Proposed frequency mask equations and figures for electrical PMDs, AUIs, and test fixtures

Associated comments: 374, 527, 378, 379, 380, 387, 388, 393, 445

Adee Ran, Cisco

Figure 178-5

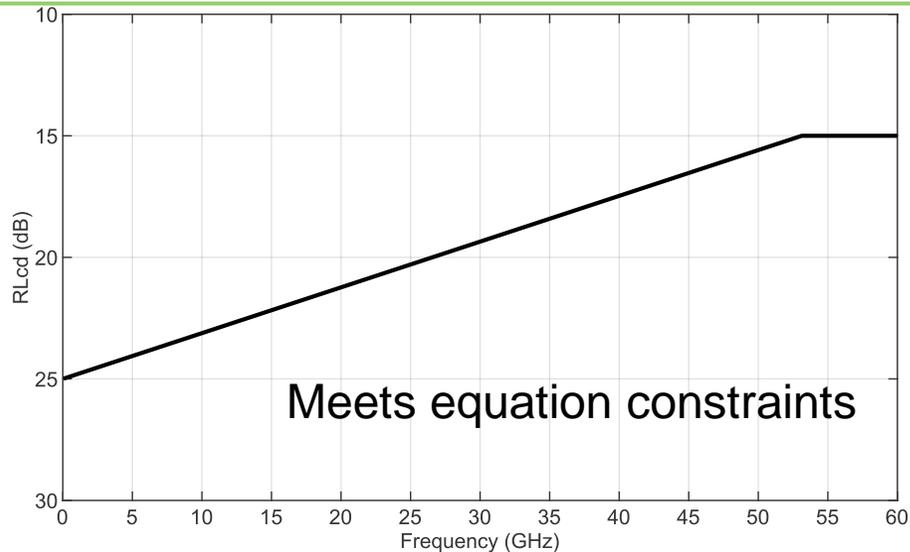
Comment #374: 178.9.3.6, KR Receiver RLcd

Comment # 527 suggests the same equation with upper frequency limit of 106.25 GHz

Proposed Equation (178-4):

$$RL_{cd}(f) \geq \begin{cases} 25 - 20(f/106.25) & 0.05 \leq f \leq 53.125 \\ 15 & 53.125 \leq f \leq 60 \end{cases}$$

Figure 178-7

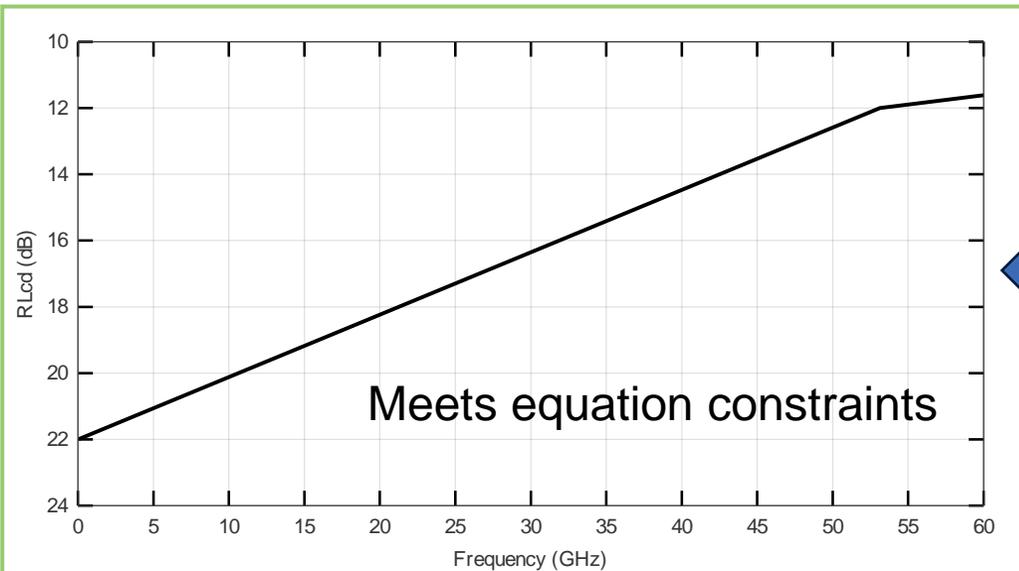
Comment #378: 178.10.4, KR channel RLcd

Proposed Equation (178-6):

$$RL_{cd}(f) \geq \begin{cases} 22 - 10(f/53.125) & 0.05 \leq f \leq 53.125 \\ 15 - 3(f/53.125) & 53.125 \leq f \leq 60 \end{cases}$$

Figure 178-8

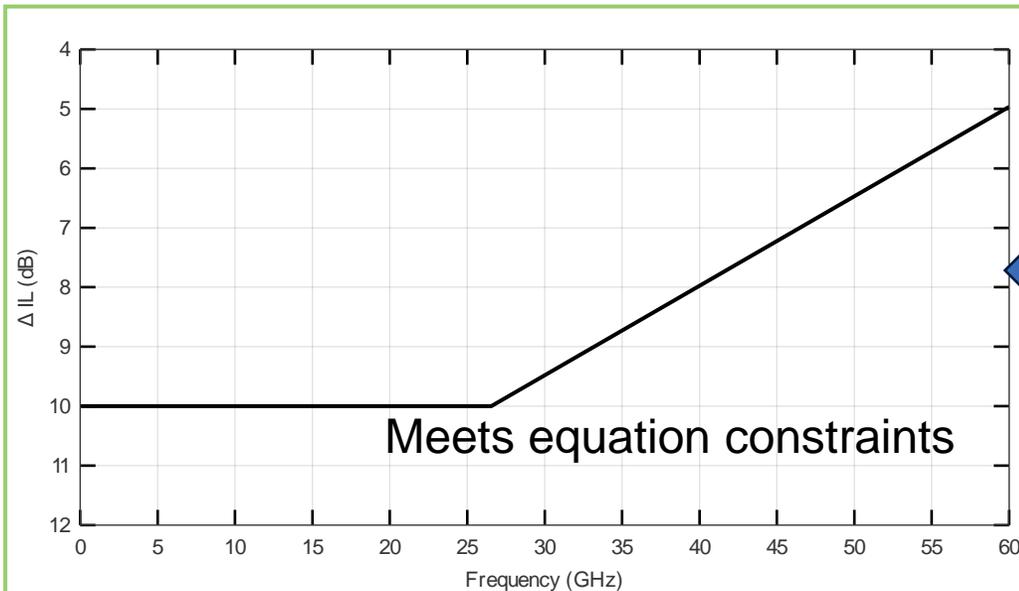
Comment #379: 178.10.5, KR channel $IL_{cd} - IL_{dd}$

Equation modified from the suggested remedy

Proposed Equation (178-7):

$$IL_{cd}(f) - IL_{dd}(f) \geq \Delta IL(f)$$

$$\Delta IL(f) = \begin{cases} 10 & 0.05 \leq f \leq 26.5625 \\ 10 - 8(f - 26.5625) / 53.125 & 26.5625 \leq f \leq 60 \end{cases}$$

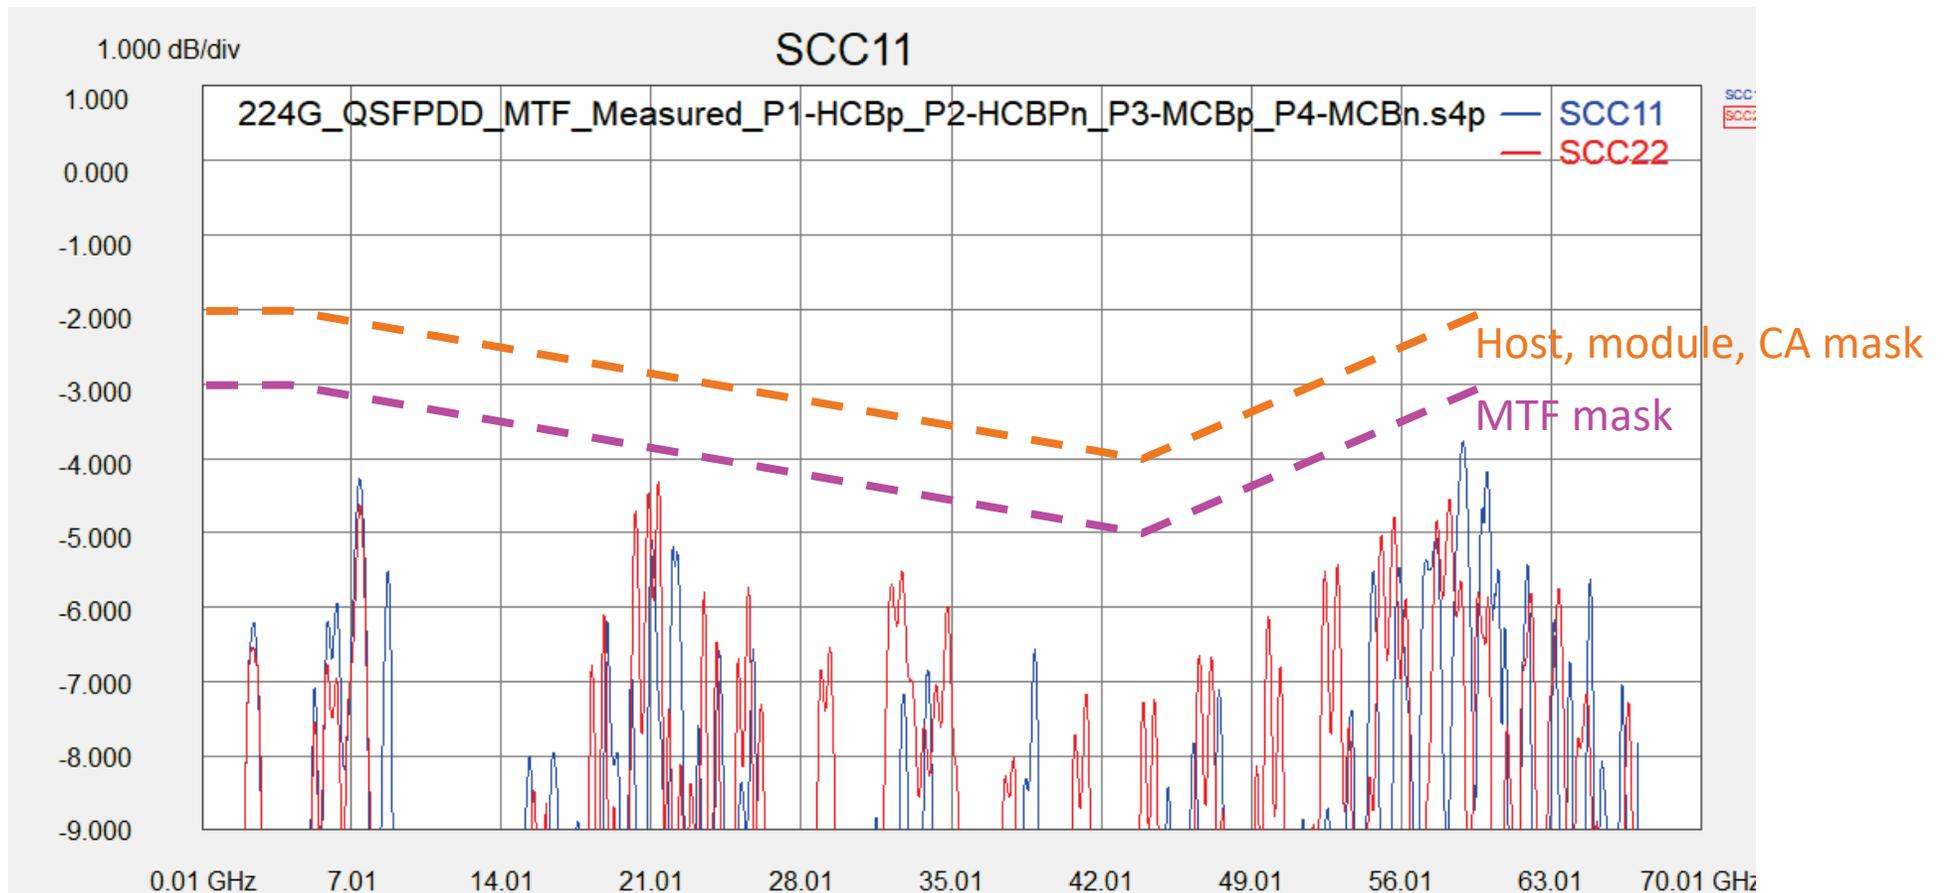
- The comment notes that in clause 162, the PMD Tx RLcc mask is piecewise-linear, with limits ranging from 2 to 4.5 dB, based on reasoning provided in [dawe 3ck 01 0422](#), including measurements of mated test fixtures.

- MTF RLcc was not addressed by the comment.
 - Recently provided measurements of mated test fixture ([sekel 3dj 02 2407](#)) show RLcc with somewhat different characteristics from the ones contributed to 802.3ck. HCB (SCC11) and MCB (SCC22) show quite similar RLcc.

- The proposed MTF mask is a modified version of that of Annex 162B. It has a minimum distance of 0.45 dB from RLcc of the MCB (at a single frequency point); the distance is larger for the HCB.

- It is suggested to use one RLcc mask for both sides of the MTF, and another mask for host, module, and cable assembly, relaxed by 1 dB.
 - Adjustments of the masks for specific interfaces can be made later if needed.

Figure 179B-4

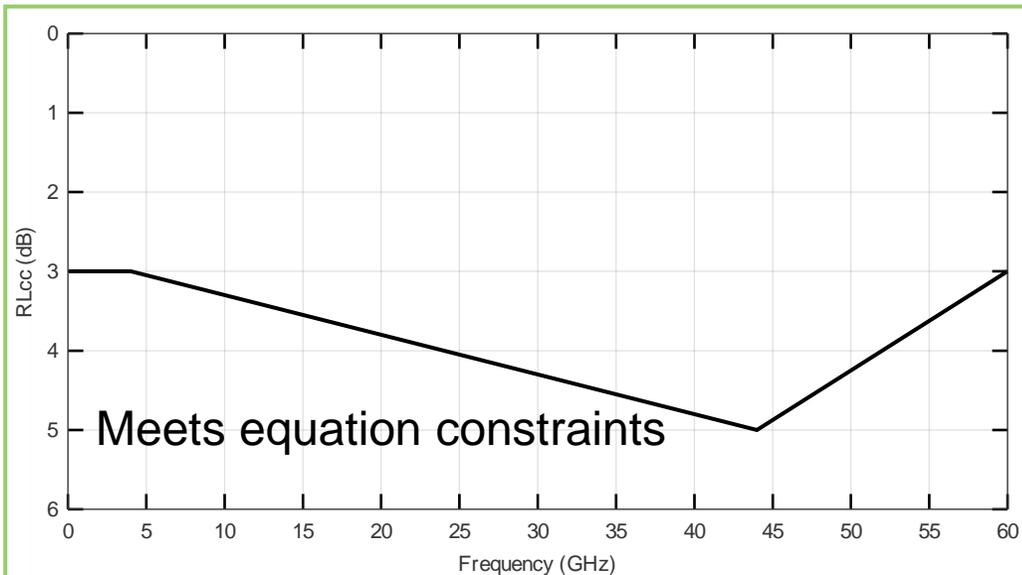
Comment #387: 179B.4.4, MTF RLcc

Not included in the original suggested remedy

Proposed Equation (179B-7):

$$RL_{cc}(f) \geq \begin{cases} 3 & 0.05 \leq f \leq 4 \\ 3 + 2/40(f - 4) & 4 \leq f \leq 44 \\ 5 + 2/16(44 - f) & 44 \leq f \leq 60 \end{cases}$$

Figure 179-4

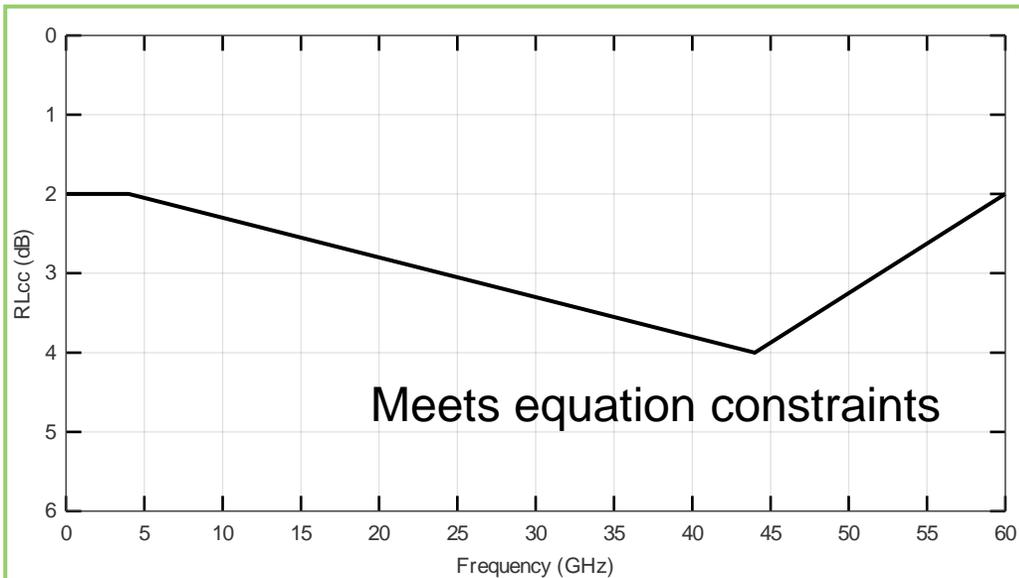
Comment #387: 179.9.4.9, CR+C2M RLcc (Host/module)

Equation modified from the suggested remedy

Proposed Equation (179-9):

$$RL_{cc}(f) \geq \begin{cases} 2 & 0.05 \leq f \leq 4 \\ 2 + 2/40(f - 4) & 4 \leq f \leq 40 \\ 4 + 2/16(44 - f) & 40 \leq f \leq 60 \end{cases}$$

Figure 179-4

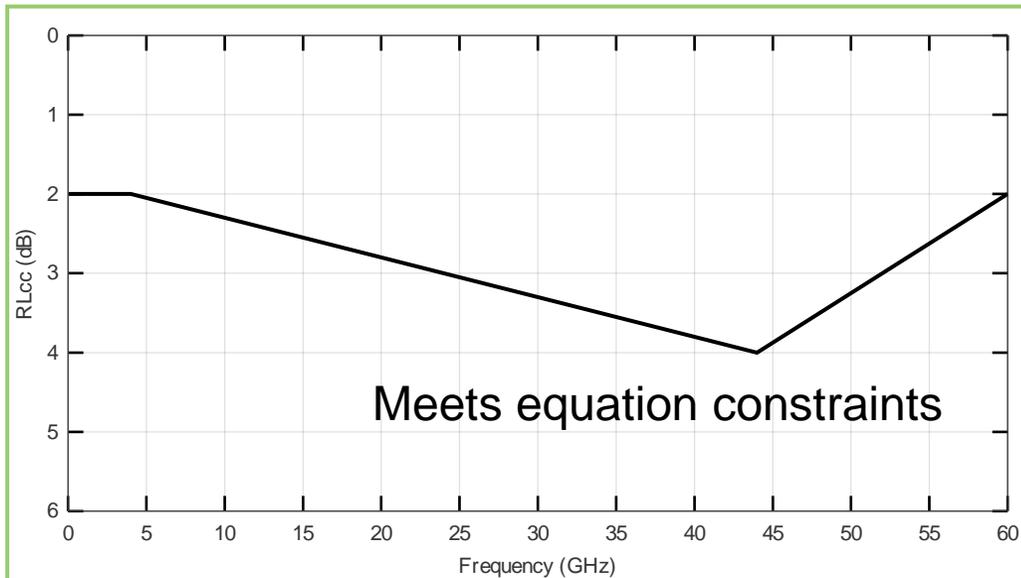
Comment #387: 179.9.4.9, CR+C2M RLcc (Cable assembly)

Equation modified from the suggested remedy

Proposed Equation (179-9):

$$RL_{cc}(f) \geq \begin{cases} 2 & 0.05 \leq f \leq 4 \\ 2 + 2/40(f - 4) & 4 \leq f \leq 40 \\ 4 + 2/16(44 - f) & 40 \leq f \leq 60 \end{cases}$$

Proposed RLdc masks in comparison to measured MTF ([sekel 3dj 02 2407](#))

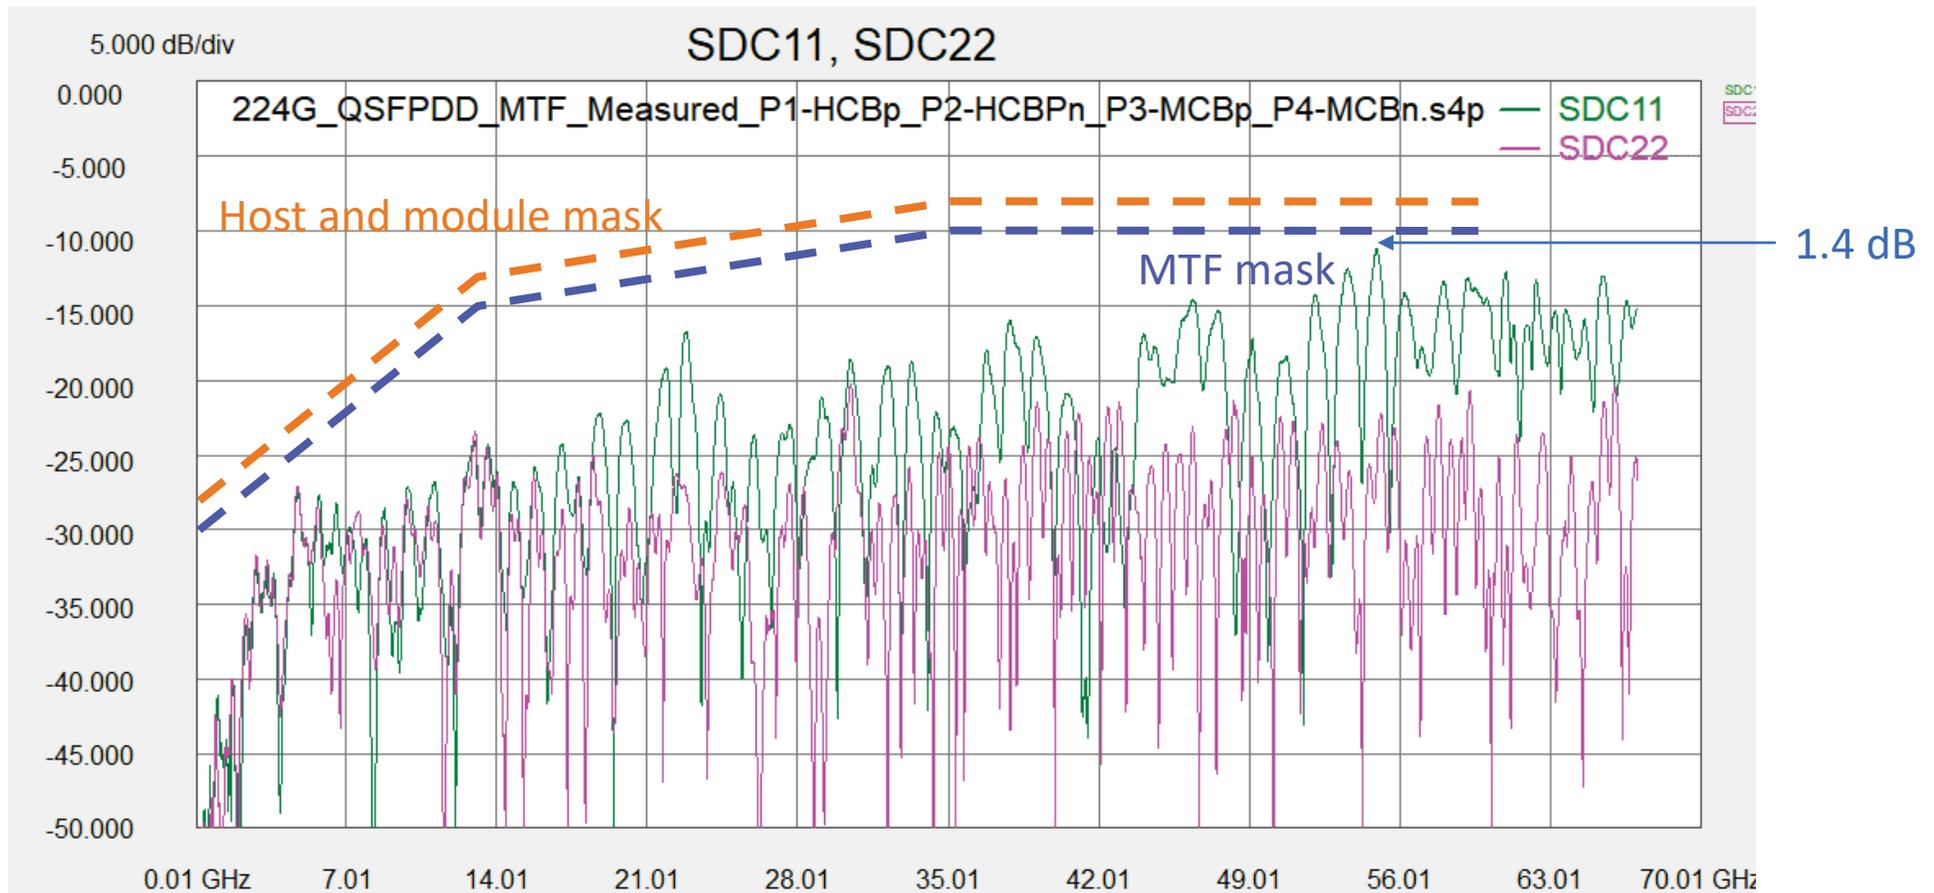
- The comments note that in Clause 162, the PMD Tx **RLdc** mask is the same as the cable assembly **RLcd**, which is based on reasoning provided in [diminico 3ck 01 1020](#) including measured cable assemblies (see also comment resolution slide 4 in [brown 3ck 03 0121](#)).

- MTF RLcd/RLdc were not addressed by these comments.
 - Recently provided measurements of mated test fixture ([sekel 3dj 02 2407](#)) show similar characteristics to the RLcd mask used in Annex 162B, with MCB-side (SDC22/SCD22) somewhat better than HCB-side (SDC11/SCD11).

- On each interface, the RLdc and RLcd are identical.
 - The proposed MTF mask is identical to that of Annex 162B extended to 60 GHz. It has minimum distance of ~1.4 dB from RLdc/RLcd of the HCB; the distance is larger for the MCB.

- It is suggested to use one RLdc mask for both sides of the MTF, and another mask for host (CR and C2M) and module, relaxed by 2 dB.
 - As in clause 162, Tx has an RLdc mask and Rx has an RLcd mask.

Figure 179B-4

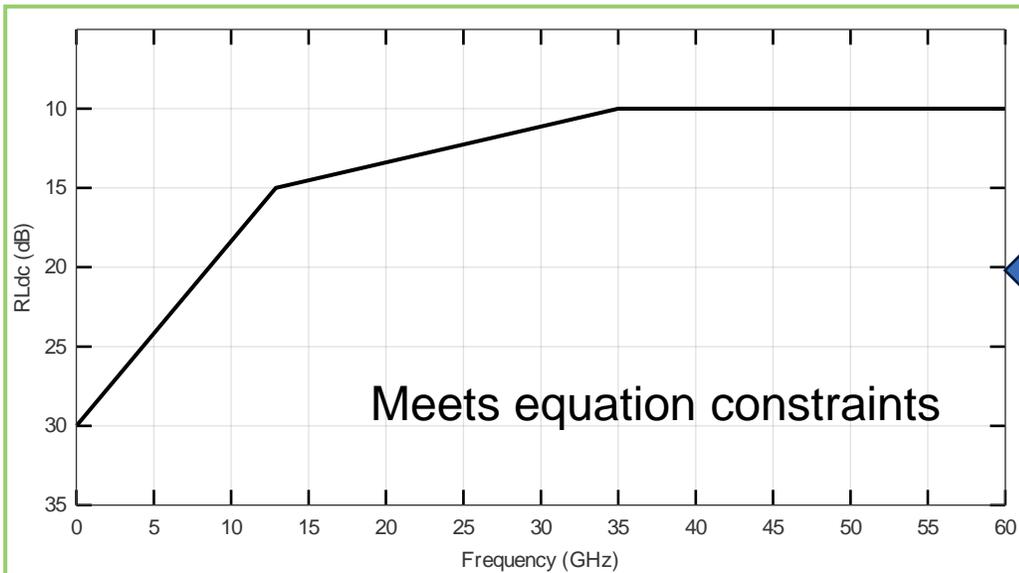
Comments #445: 179B.4.4, MTF RLdc

Equation modified from the suggested remedy

Proposed Equation (179B-8):

$$RL_{dc}(f) \geq \begin{cases} 30 - 15(f/12.89) & 0.01 \leq f \leq 12.89 \\ 15 - (f - 12.89) / (35 - 12.89) & 12.89 \leq f \leq 35 \\ 10 & 35 \leq f \leq 60 \end{cases}$$

Figure 179-5

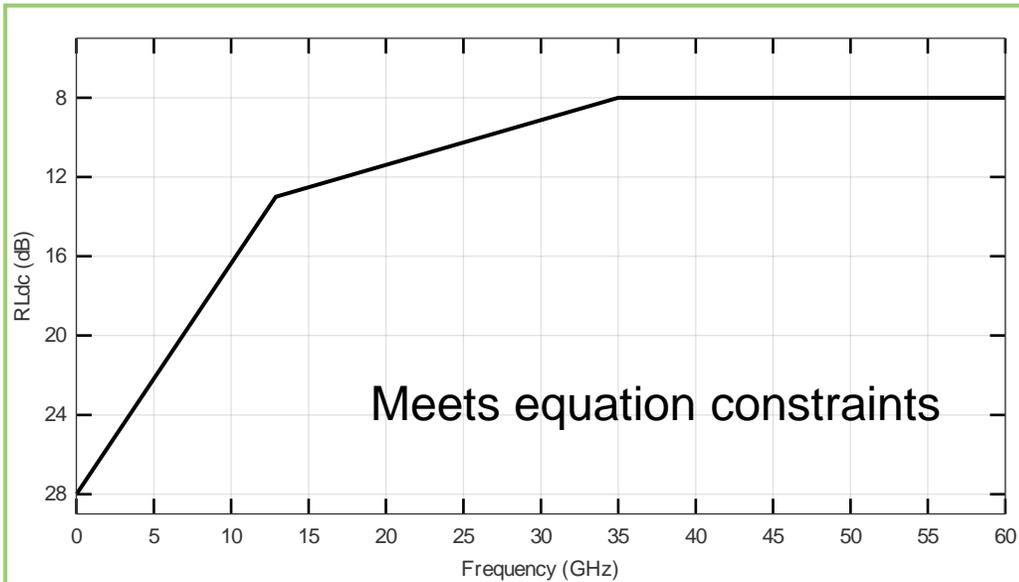
Comment #388: 179.9.4.10, Tx RLdc

Equation modified from the suggested remedy

Proposed Equation (179-10):

$$RL_{dc}(f) \geq \begin{cases} 28 - 15(f/12.89) & 0.01 \leq f \leq 12.89 \\ 13 - 6(f - 12.89)/(35 - 12.89) & 12.89 \leq f \leq 35 \\ 8 & 35 \leq f \leq 60 \end{cases}$$

Figures 179-5 and 176E-6

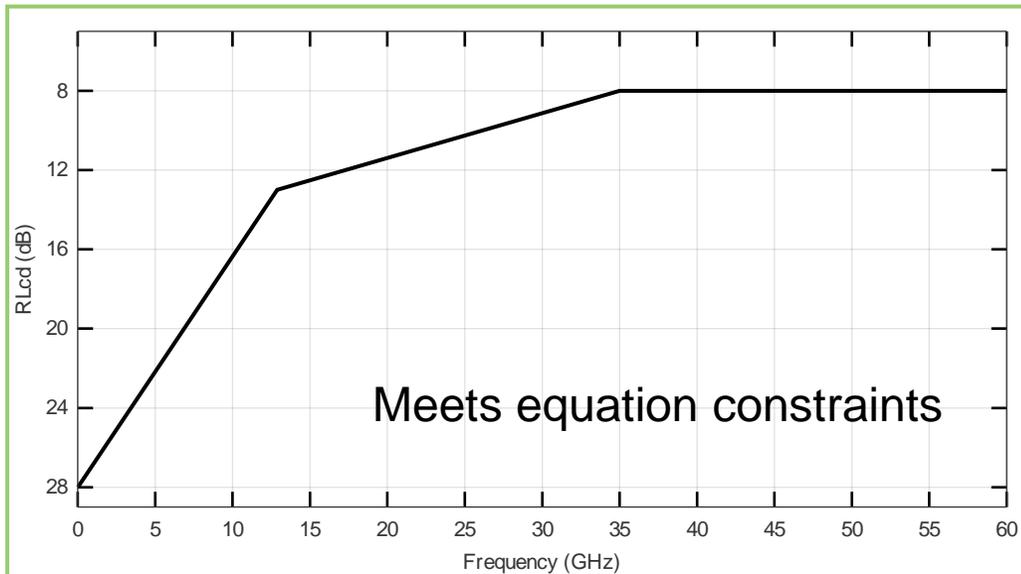
Comment #393: 179.9.5.6 and 176E.6.3, Rx RLcd

Equation modified from the suggested remedy

Proposed Equations (179-21) and (176E-2):

$$RL_{cd}(f) \geq \begin{cases} 28 - 15(f/12.89) & 0.01 \leq f \leq 12.89 \\ 13 - 6(f - 12.89)/(35 - 12.89) & 12.89 \leq f \leq 35 \\ 8 & 35 \leq f \leq 60 \end{cases}$$

Figure 179B-3

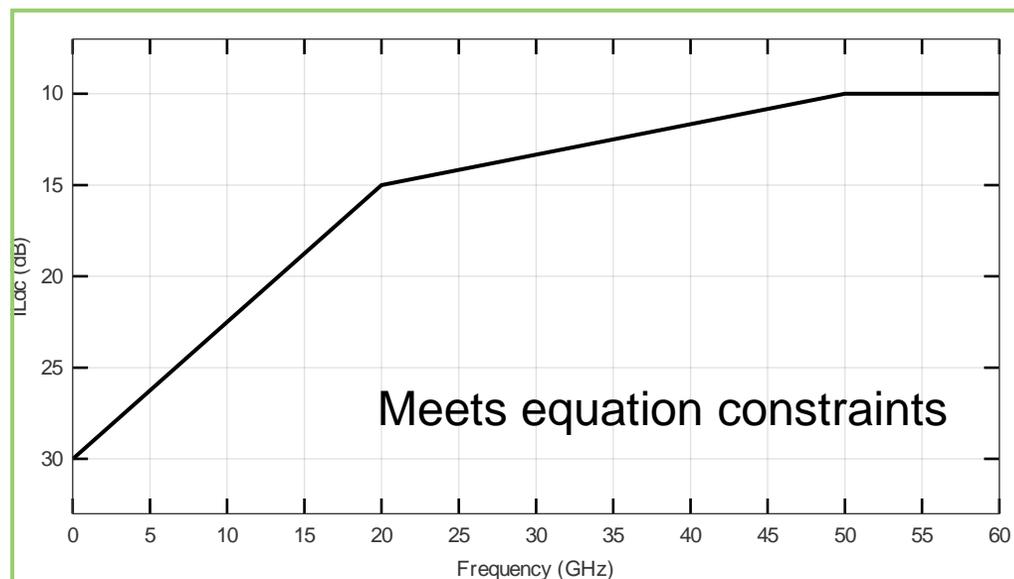
Comment #445: 179B.4.3, MTF ILdc

Equation modified from the suggested remedy

Proposed Equations (179B-6):

$$IL_{dc}(f) \geq \begin{cases} 30 - 15(f/20) & 0.01 \leq f \leq 20 \\ 15 - 5(f - 20) / 30 & 20 \leq f \leq 50 \\ 10 & 50 \leq f \leq 60 \end{cases}$$
